BCA ASSESSMENT REPORT (Rev C)

NORTH ALBURY HOUSING DEVELOPMENT

**310 – 314 SWAN STREET and 984-988 CORELLA STREET,
NORTH ALBURY**

7 February 2025

5.2 Vertical Separation of Openings in External Walls (BCA Clause C3D7)

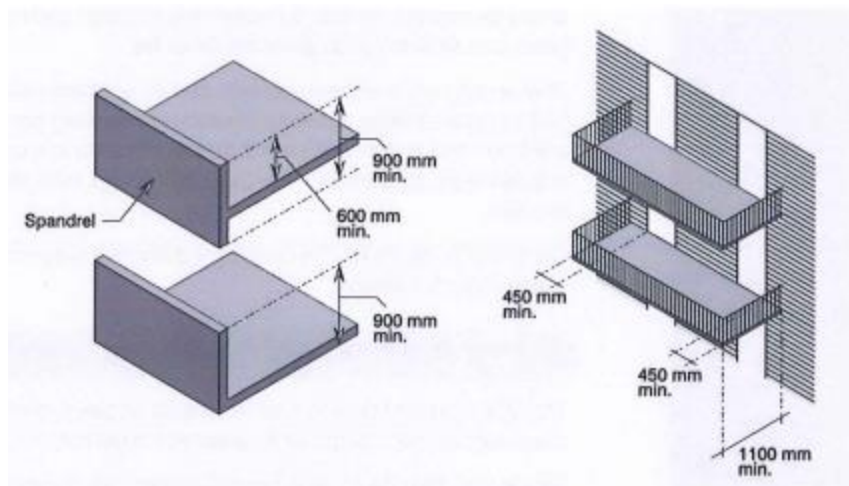
Any part of a window or other opening in the external wall that is above another opening in the storey next below and its vertical protection falls no further than 450mm outside the lower opening (measured horizontally), the openings must be separated by a fire rated spandrel or horizontal projection in accordance with BCA Clause C3D7.

The separation measures will need to be fully detailed on the construction plans to demonstrate compliance with BCA Clause C3D7.

It is important to note that an opening in relation to this requirement also relates to any part of an external wall that does not have a fire rating of at least FRL 60 minutes.

- not less than 900mm in height, and
- extends not less than 600mm above the upper floor surface, and
- is non-combustible (except timber framing permitted) having an FRL of not less than 60/60/60.

- slab or other horizontal construction that projects outwards from the external face of the wall not less than 1100mm, and
- extends along the wall not less than 450mm beyond the openings concerned, and
- is non-combustible (except timber framing permitted) and has an FRL of not less than 60/60/60.

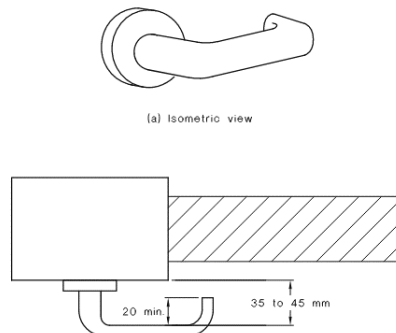
If services or equipment comprising electricity meters, distribution boards, central telecommunications distribution boards or equipment and the like are installed in a public corridor or lobby leading to a required exit they must be enclosed by non-combustible construction or a fire-protective covering with doorways or openings suitably sealed against smoke spreading from the enclosure.

Example below of electrical services in public corridor that will need to be detailed to comply with this requirement.

5.11 Stair Handrails (BCA Clause D3D17 & D3D22)

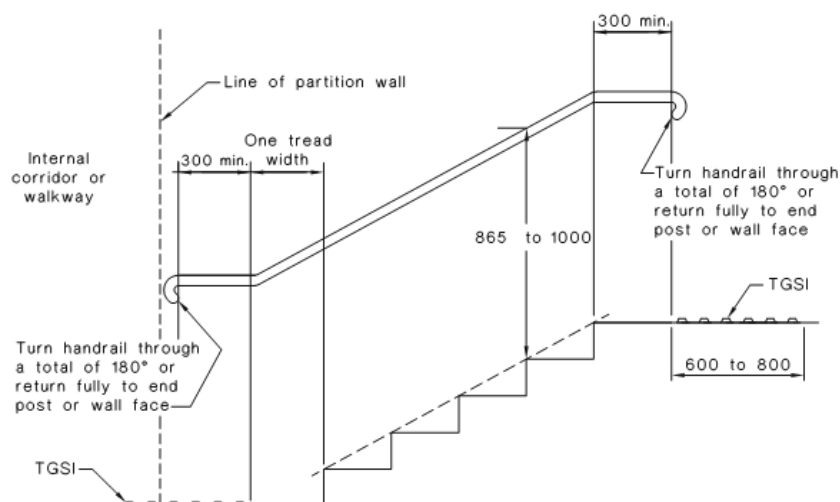
The stairways are to be provided with handrails both sides complying with AS1428.1-2009, including a minimum 50mm clearance between the handrail and the wall or other obstruction. Allowance will need to be made for the handrail extensions at the top and bottom of the stairways, and ensuring wheelchair circulation spaces are maintained in the corridors.

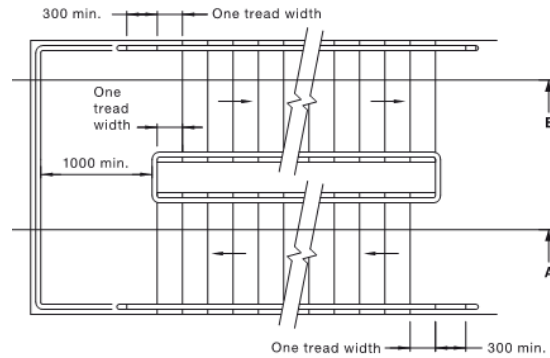
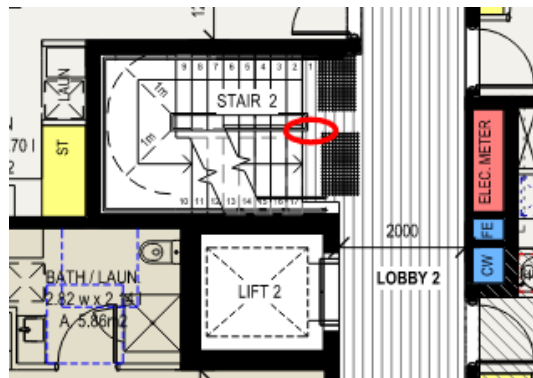
It is also important to highlight the requirement of BCA Clause D3D22(1)(f) which requires handrails to stairways that serve areas that are required to be accessible must comply with Clause 12 of AS1428.1-2009. This clause requires the handrail height to be consistent through the stairway and landings. Therefore it is important to design all stairs that contain more than one flight, so that the stair treads are offset at landings to achieve the consistent handrail height at the landing locations.

Below is an example of where the handrail on the proposed stairs needs to extend (one tread width) to maintain the handrail height down the stair flight before turning.

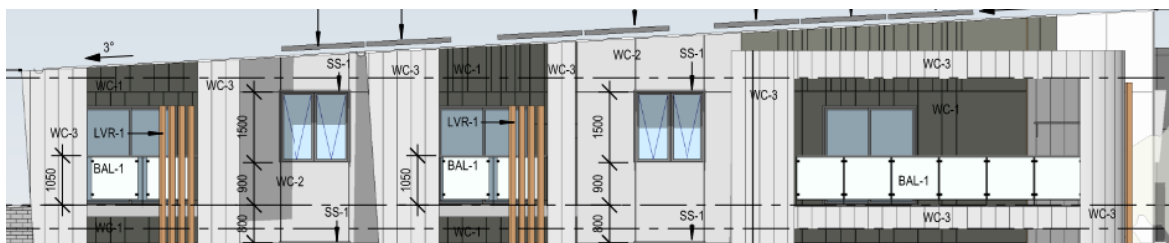
In relation to the balustrade height if designing a true horizontal top to the balcony balustrades, it is important to allow for any proposed sloping on the balcony floors.

Further on balconies where the fall is more than 4m (ie. Second Floor), balustrades must not contain climbable elements between 150mm and 760mm above the floor. It is important to detail the transition point with any different balustrade types or intersection with other features/elements, to ensure there are no climbable members within this nominated zone.

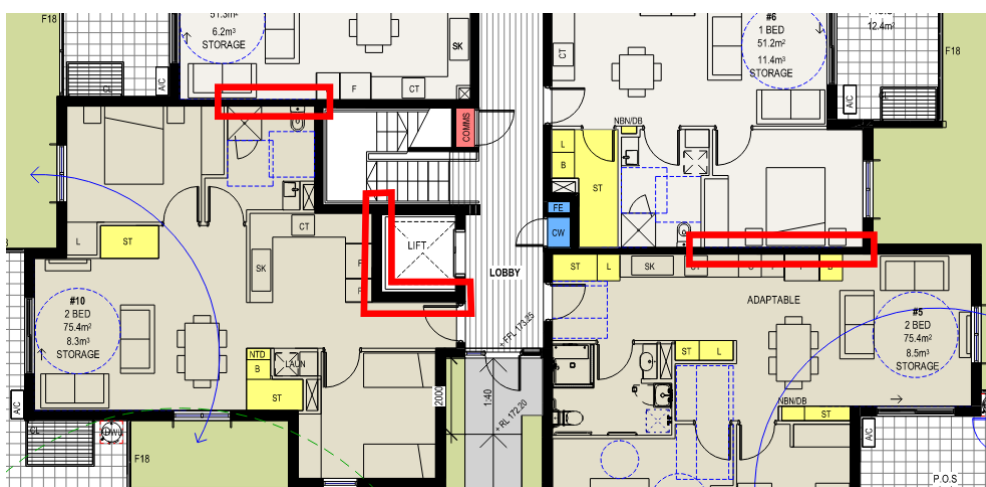
It is noted on the preliminary plans that the fire hydrant system will utilise the street fire hydrants. Pressure and flow details will need to be obtained from the local water authority to ensure that sufficient pressures and flows are available in the main to comply with AS2419.1-2021.

Furthermore it is important to accurately locate these street hydrants and ensure they will be located at least 10m from the building, as per AS2419.1-2021 requirements.
